Planning Application Ref, APP/16/00387 :- No. 1. Fairlea Road, PO10 7SX

Further to the Council's Notice of a Planning Application I submit my observations and comments. In this regard, I advise my objection to the Planning Proposal.

Enc: Photographs, 4No. A4 sheets.

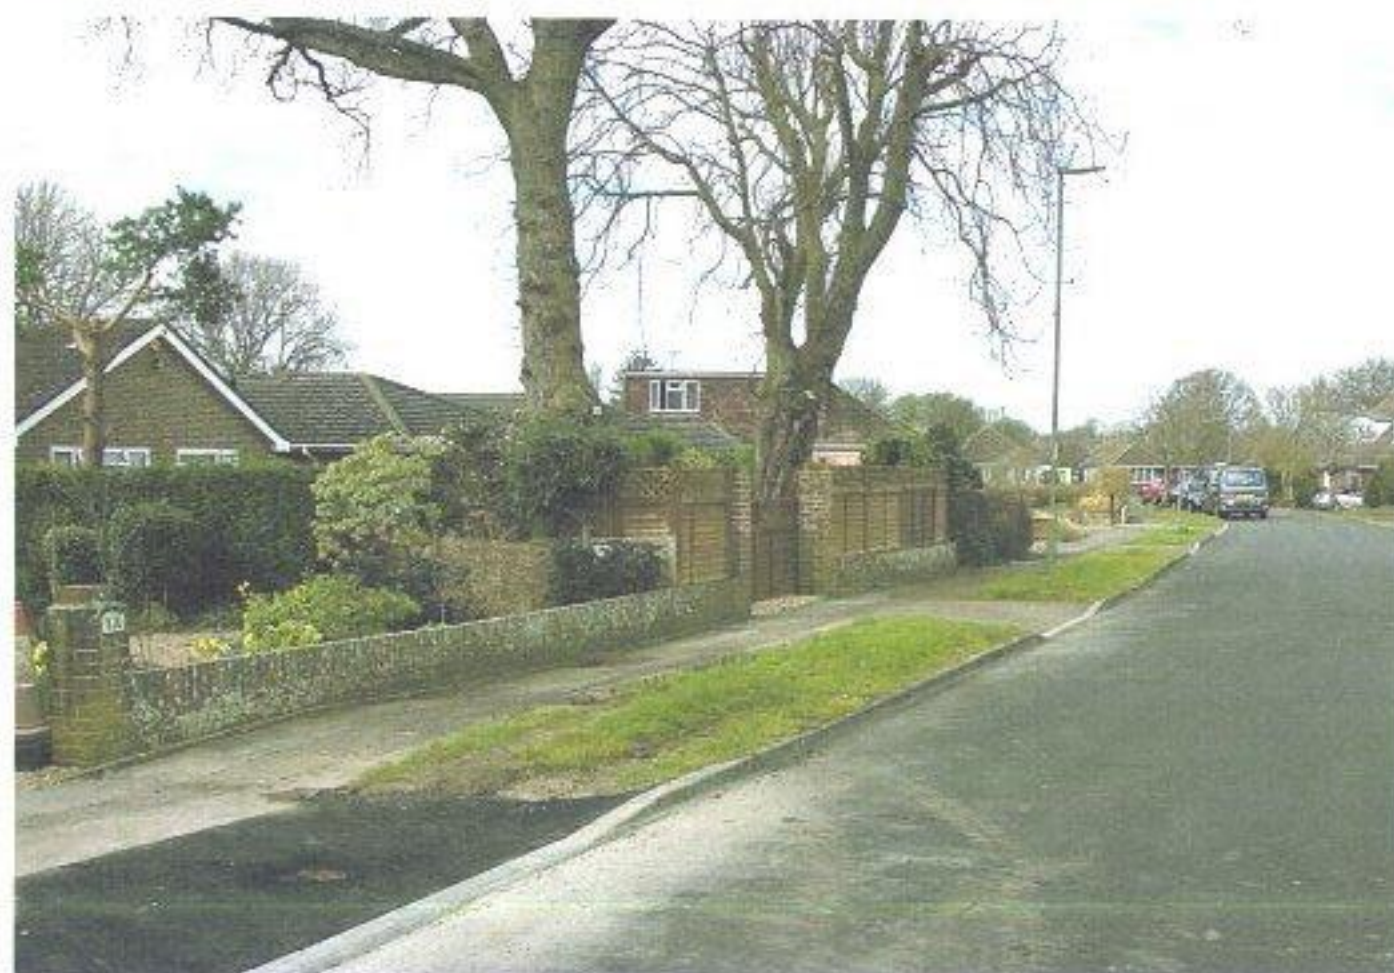
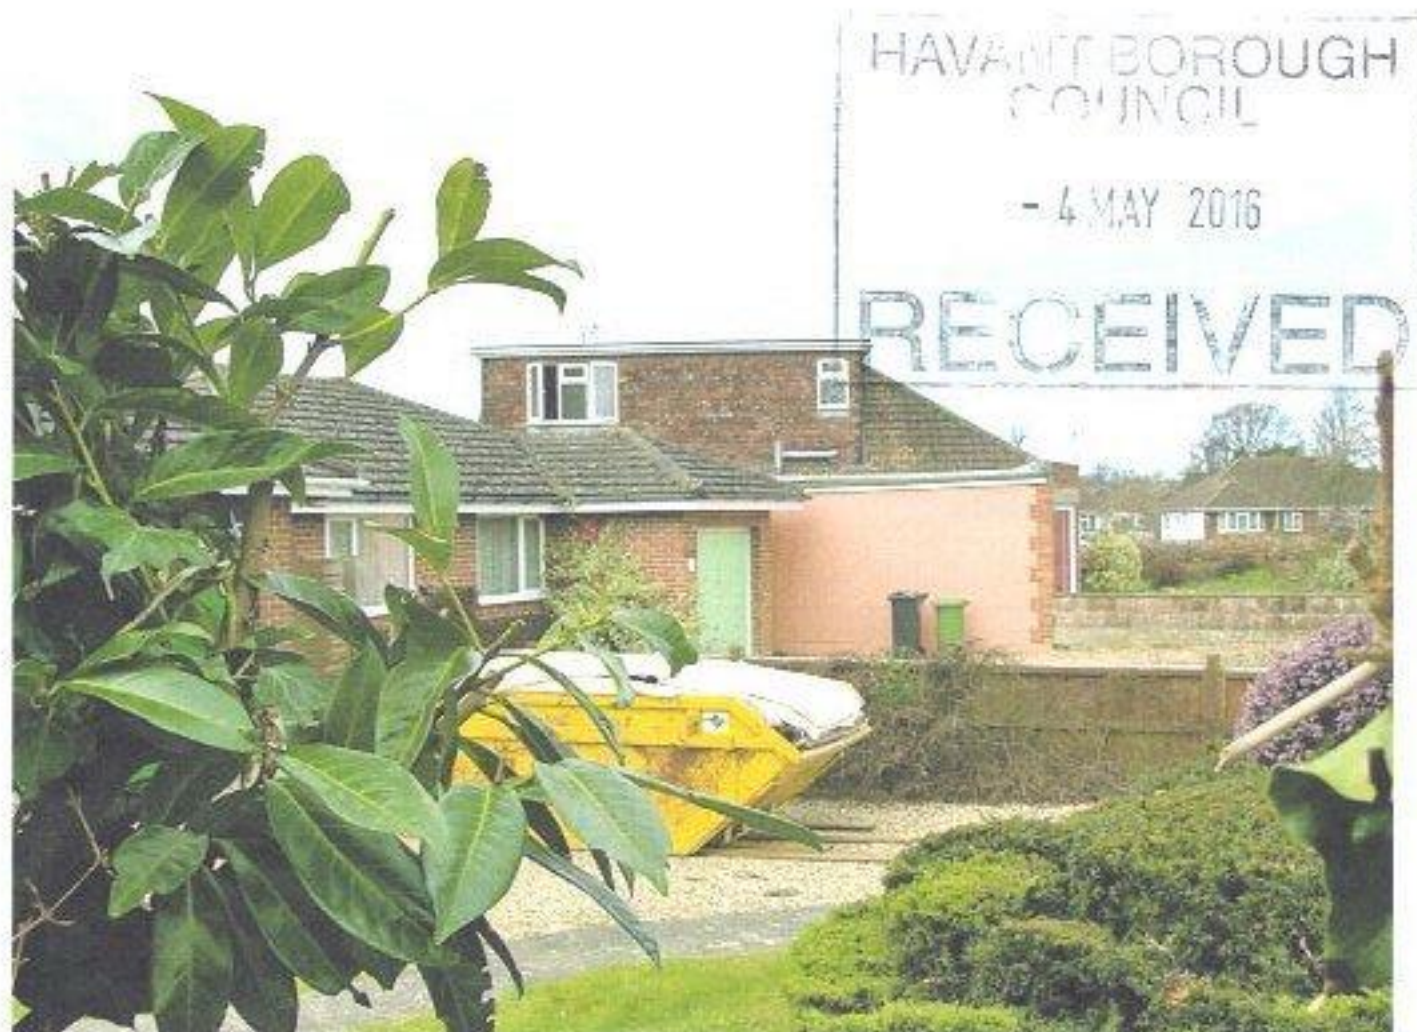
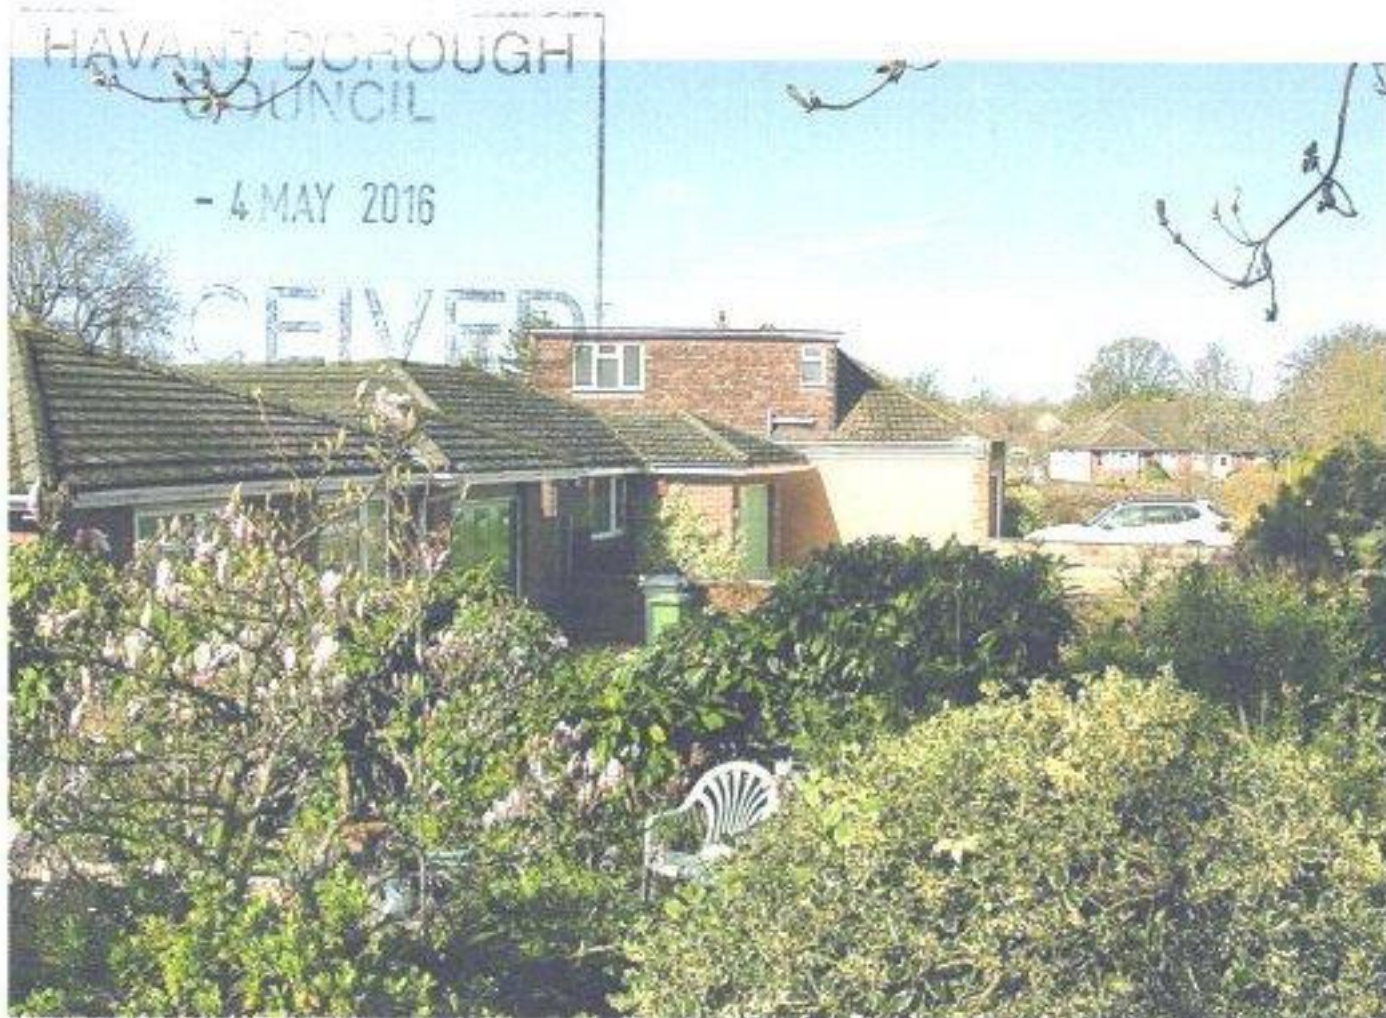
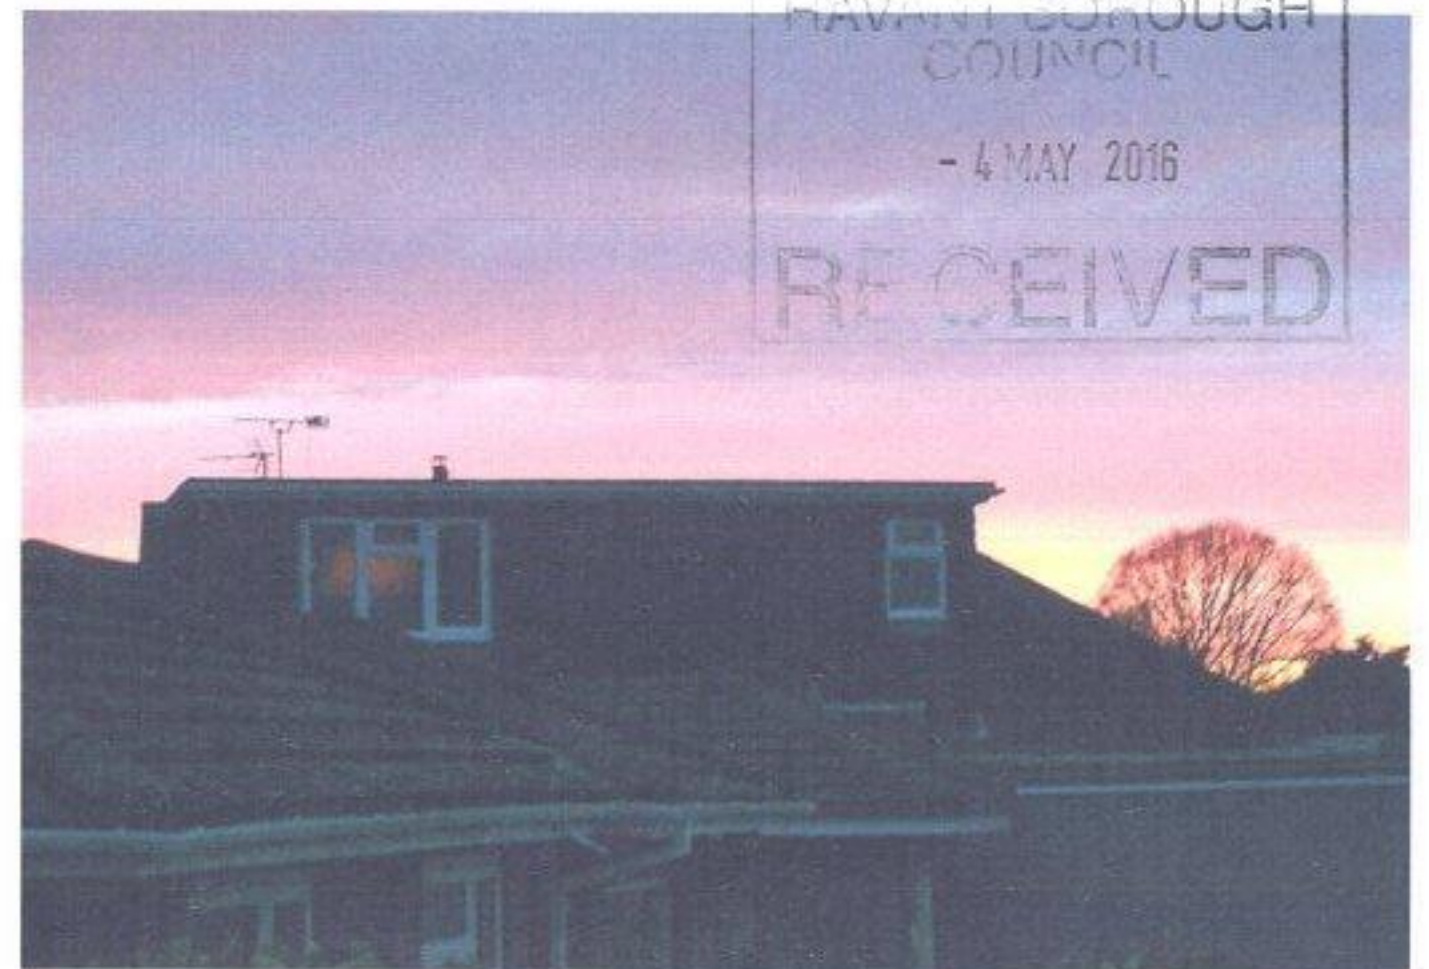
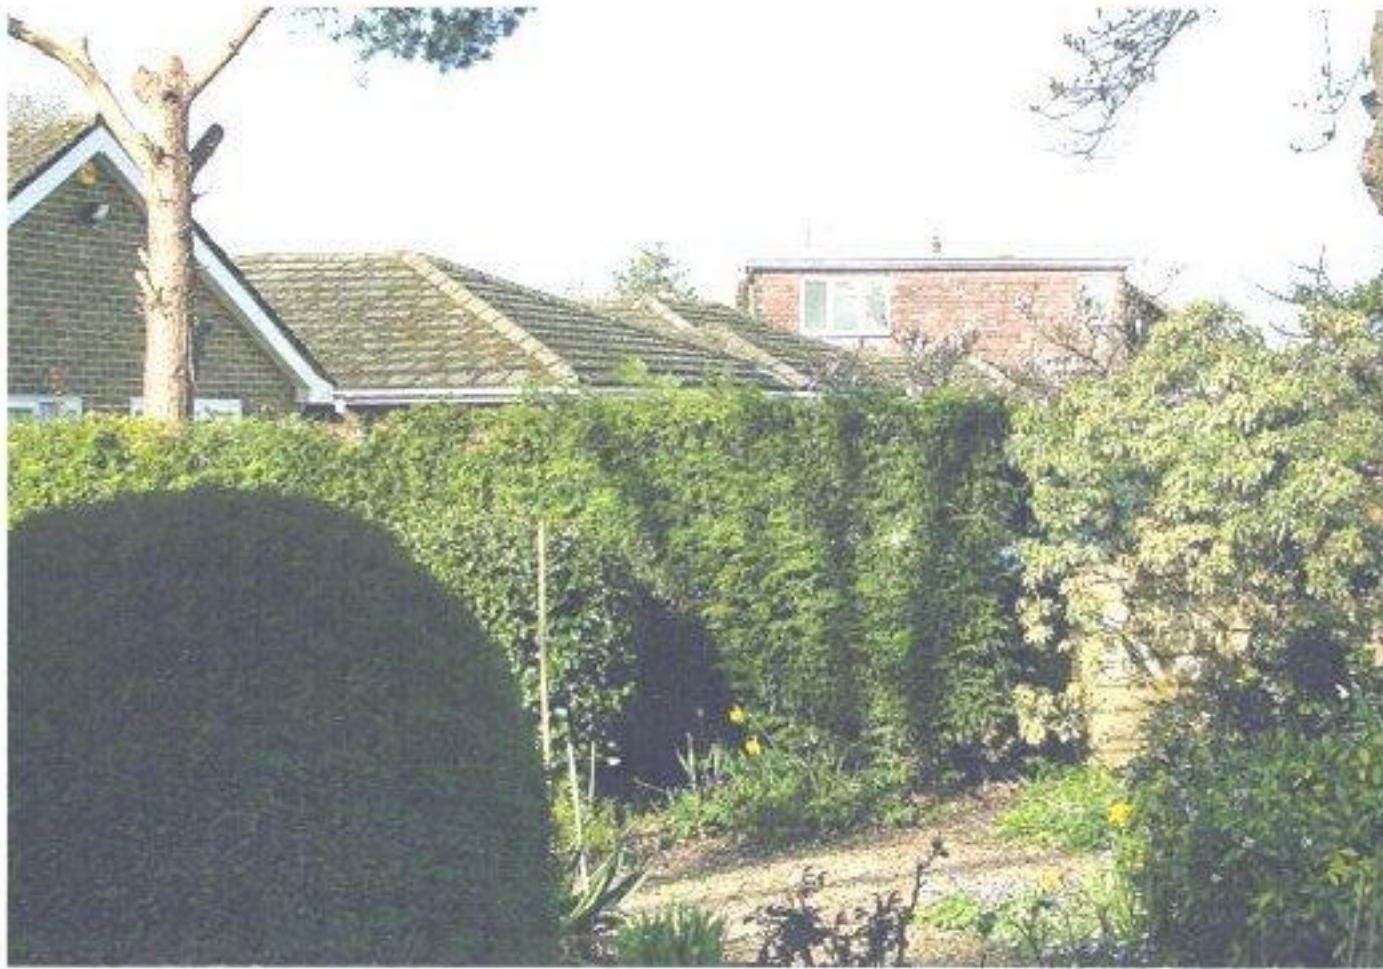
The new second floor windows currently appear to have a temporary covering of a semi-translucent opaque material, with the potential to create an illusion of obscured glass. When this material is removed the clear glass would be fully revealed. Associated with this is the submitted Planning Application Form, stating the windows as "white UPVC to match existing", giving no reference to the use of obscured glass, or fixed glazing. I would therefore, respectfully suggest that the Council obtains up-to-date clarification on existing windows, and any related implication for proposed glazing.

The development has converted an existing bungalow to create a second floor of occupancy, to a height above, the top of its immediate neighbours, (to the east) overlooking my home and other bungalows in Fairlea Road. The dimensions and bulk of the development has, in my opinion, created a dominant two story dwelling, with windows looking down, upon neighbouring bungalows and gardens. Thereby, adversely affecting the privacy and amenity value of our homes in Fairlea Road, as well as being detrimental to the street scene and character of this established residential cul-de-sac. I am, therefore opposed to any proposal that will adversely affect Fairlea Road, beyond that allowed under both permitted development and building regulations. Evidential photographs enclosed herewith.

Finally, I question, if the construction is fully compliant with the submitted roof plans and planning requirements. The cross-section, shows the top of the roof to be below the top of the rafters with the ridge tiles set above. From the street view, it appears that the top of the roof is higher than both the rafters and any bedding for the ridge tiles, thus possibly at variance to the cross-section and front and rear elevations shown on the drawings. It appears that at the present time the ridge tiles have not been replaced, with the potential to further increase the roof height.

Most, essentially, I ask that any upper floor windows, if permitted, are permanently fixed closed, and are fitted with permanent obscured glass glazing.
